Access Compliance Report

Public Rights-of-Way

(Curb Ramps)

Intersection ID: N/A	Main Street: INDEPENDENCE_RD	Cross Street: N/A	Location: SE
ADA ID: B4EE427332CF	Ramp Type: PerpDiag	Initial Pass/Fail: Fail	Overall Compliance: No
Severity Score: 12.5			
Codes/Mitigation Info/Possible Solution		Field Measurements/Component Compliance

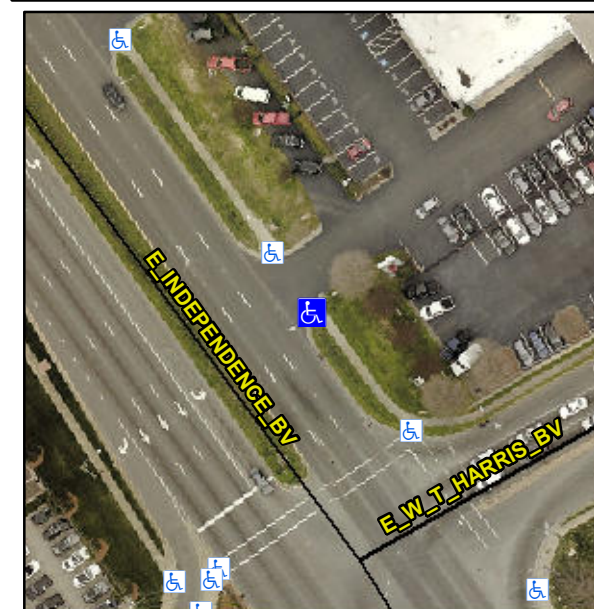
Not Found, R304.5.3

Compliance	Description	Data	Compliance	Description	Data
N/A	Ramp Length (in)	62.0	Yes	Ramp Slope (%)	7.8
Yes	Ramp Width (in)	54.0	No	Ramp XSlope (%)	5.2
N/A	Flare Type LT	N/A	N/A	Flare Type RT	N/A
N/A	Flare Slope LT (%)	N/A	N/A	Flare Slope RT (%)	N/A
N/A	Flare Traversable LT?	N/A	N/A	Flare Traversable RT?	N/A
N/A	Landing Length (in)	N/A	N/A	DWS Provided?	N/A
N/A	Landing Width (in)	N/A	N/A	DWS Contrast?	N/A
N/A	Landing Slope (%)	N/A	N/A	DWS Length (in)	N/A
N/A	Landing X Slope (%)	N/A	N/A	DWS Full Width?	N/A
N/A	Landing Curb? (Y/N)	N/A	N/A	DWS Offset (in)	N/A
N/A	Shared Landing?	N/A			
N/A	Gutter Ponding?	N/A	N/A	Gutter Slope (%)	N/A
N/A	Gutter Lip Ht (in)	N/A	N/A	Gutter X Slope (%)	N/A
N/A	Painted X Walk1?	No	N/A	Painted X Walk2?	No
	X Walk 1 Direction	To NW		X Walk 2 Direction	To W
N/A	X Walk 1 Width (in)	N/A	N/A	X Walk 2 Width (in)	N/A
	X Walk 1 Slope (%)	4.8		X Walk 2 Slope (%)	2.8
	X Walk 1 X Slope (%)	2.2		X Walk 2 X Slope (%)	2.9

Remove & Replace Curb Ramp With Two New Directional Ramps or Equivalent.
